# 2015\ENQ\00689 Planning Enquiry Park Road Barnsley Proposed Development

Responses to Objections Raised

Peter J Firth (Applicant)

Proposed development street view (using actual photo of No 44 Locke Avenue recent Development and accounting for correct scaling. Below fence is first floor + parking ground floor).

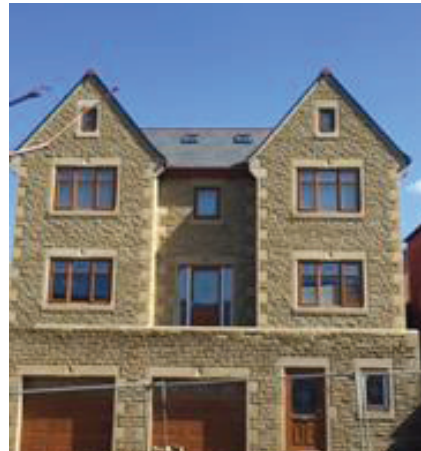
- **Objection #1 as stated:** It appears to be approximately twice as wide as other dwellings on Locke Ave so does not fit in with existing character

- As can be seen from the mock up (which is approximately scaled correctly) it is in fact less than the width of the nearest semi-detached house
- The appearance can be made up as that of a semi-detached house with halves at either side similar to the new house at 44 Locke Avenue as used for mock-up.
- Stone fronting can be used as per neighbouring three houses (as shown)

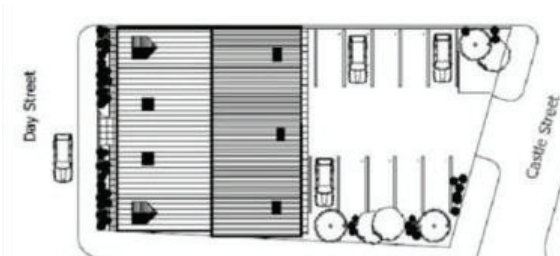
- **Objection #3 as stated:** The spd states that where proposed dwelling is over 2 storeys in height ( excluding rooms in roof space) the separation distance should increase so the distance to 263 Park Road may have to be 14m not 12.0m,as this dwelling is proposed to be 3 stories to the rear.

- As you can see from the mock up, there is in fact only going to be two stories above road level and the parking and first floor are below so we are using effective basement level for accommodation and parking like there will be in other houses on the street also.
